**CITY OF NOVI CITY COUNCIL
NOVEMBER 25, 2024**

SUBJECT: Consideration of tentative approval of Sakura East JZ23-41 with Zoning Map Amendment 18.743, to rezone from Light Industrial to Town Center One with a Planned Rezoning Overlay (PRO).

ORIGINAL ISSUE DATE:
MAY 13, 2024
DRAWING TITLE
PRELIMINARY SITE PLAN

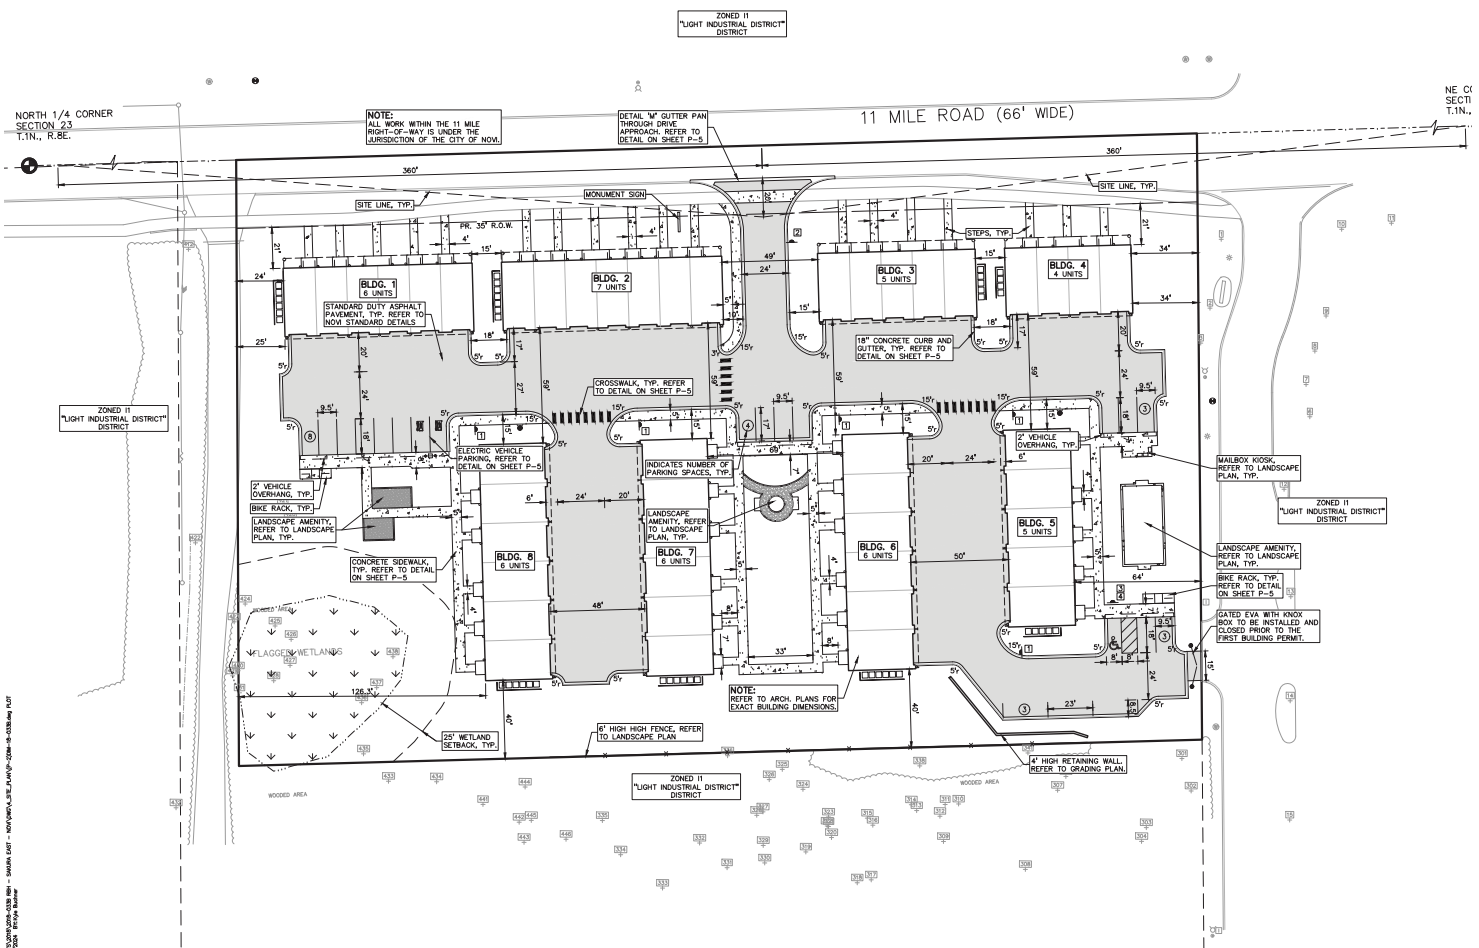
- a. An in-depth explanation of the need for a Wetland and Watercourse Setback can be found on page 3-67 of the [City of Novi Zoning Ordinance](#).
 - b. No impacts are proposed to the on-site Wetland. However, impacts appear to be proposed to the 25-foot Wetland Setback. Sheet P-2 shows a small portion of concrete sidewalk will be

placed within the 25-foot Wetland Setback. Additionally, Sheet P-3 shows proposed contours (between 903-906 feet above mean sea level) will occur within the 25-foot Wetland Setback.

sheet title:
Landscape Plan - West

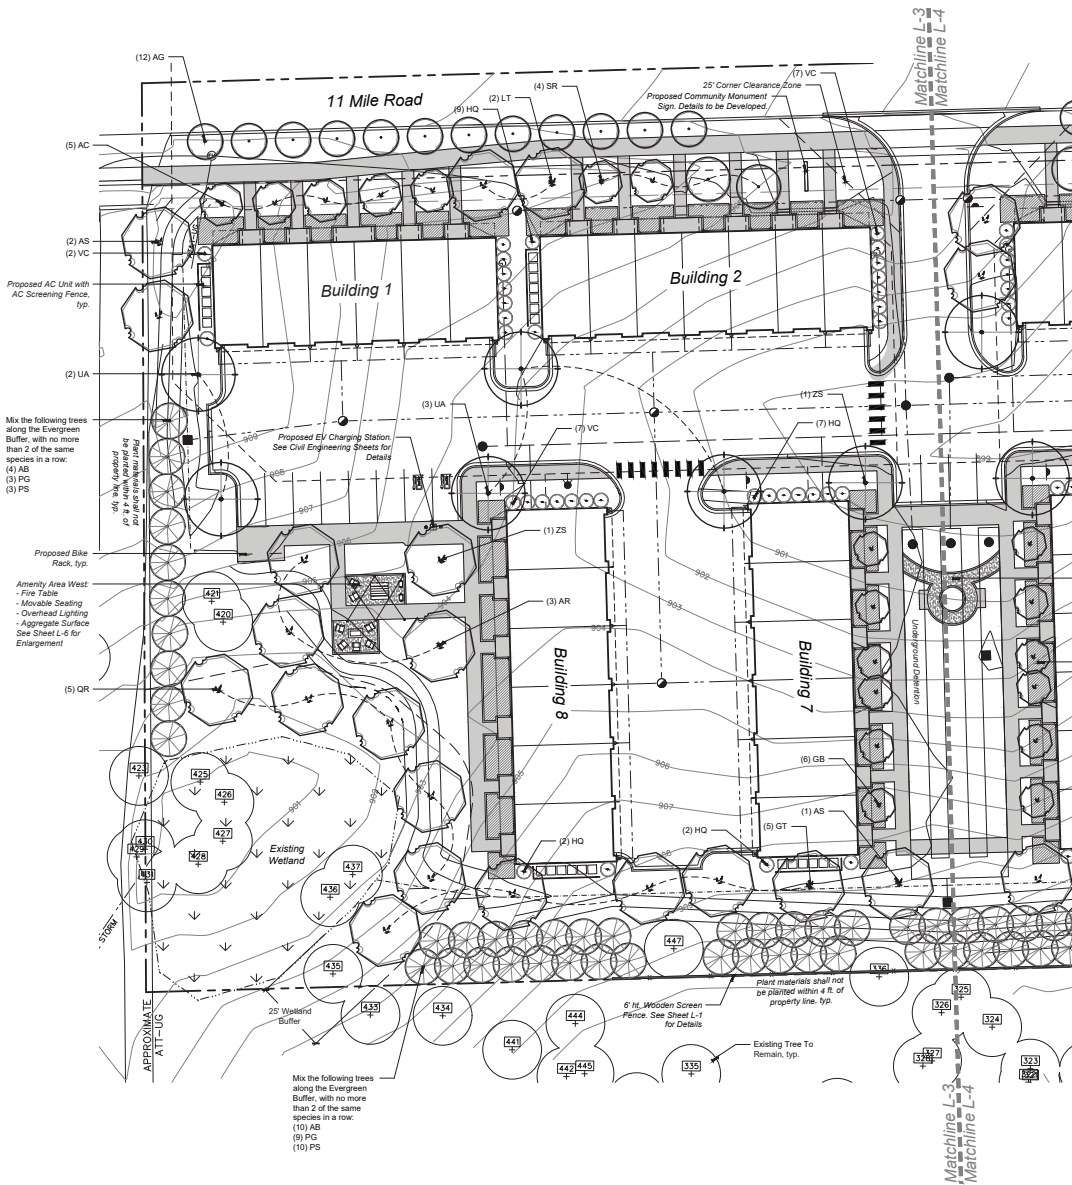
- Restoration techniques of the setback area. Sheet L-3 displays seven proposed *Quercus rubra* trees will be planted within the setback area. An explanation should be provided with the type of erosion prevention that will be used to restore the setback area and prevent excess sedimentation within the wetland upon construction completion.

sheet title:
**Public Wetland
Overlook Amenity**

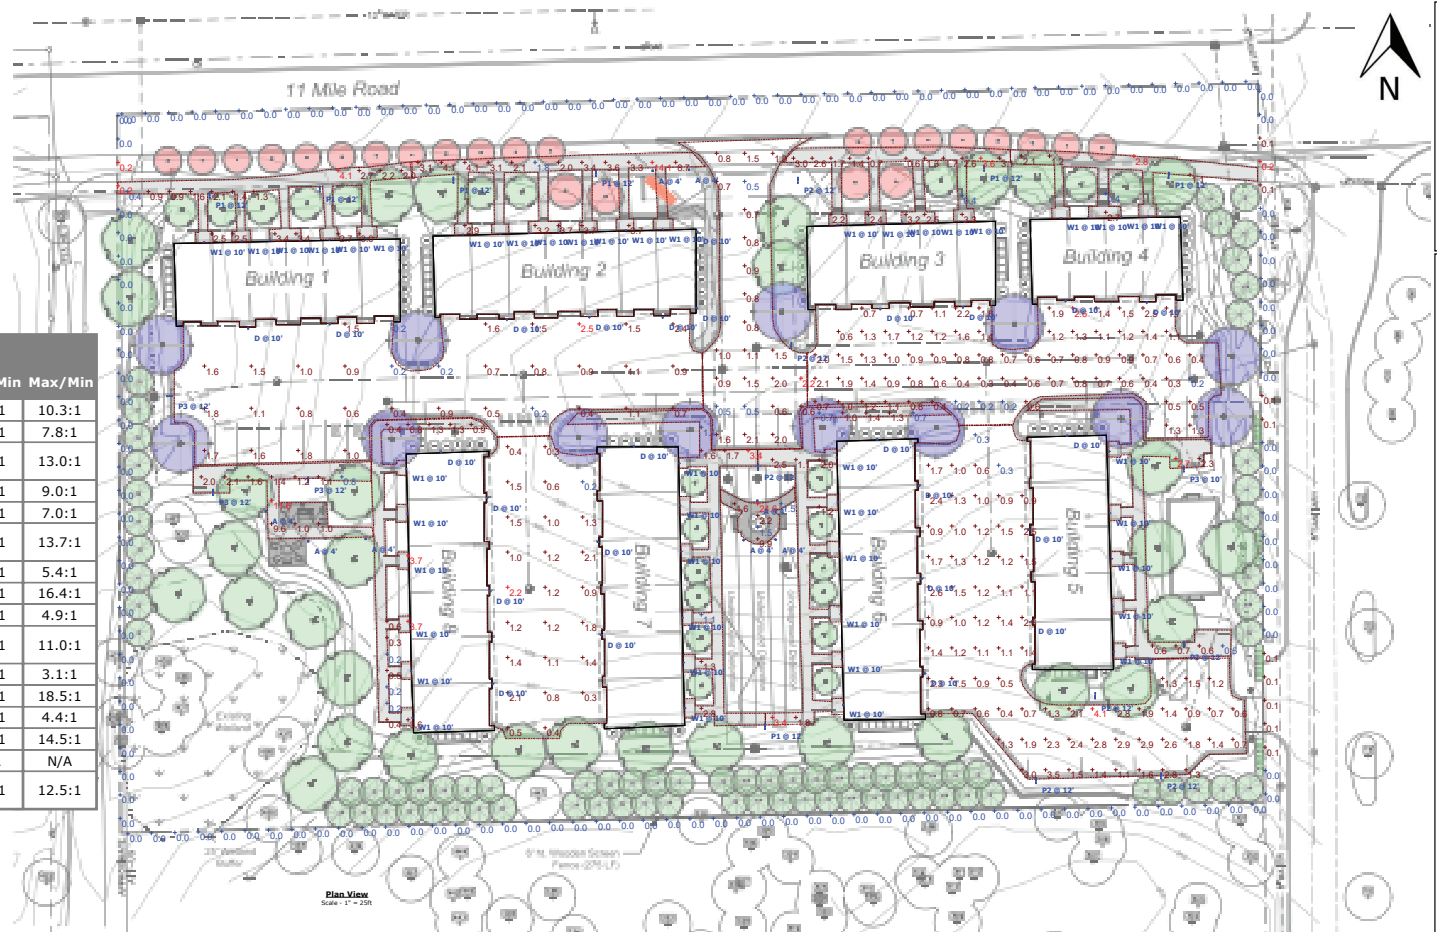
5. A publicly accessible wetland overlook amenity to be provided on the City's parcel on the **east** side of the pond with similar amenities as shown on the plan for the west side of the pond, that shall be shown on a revised PRO Plan.
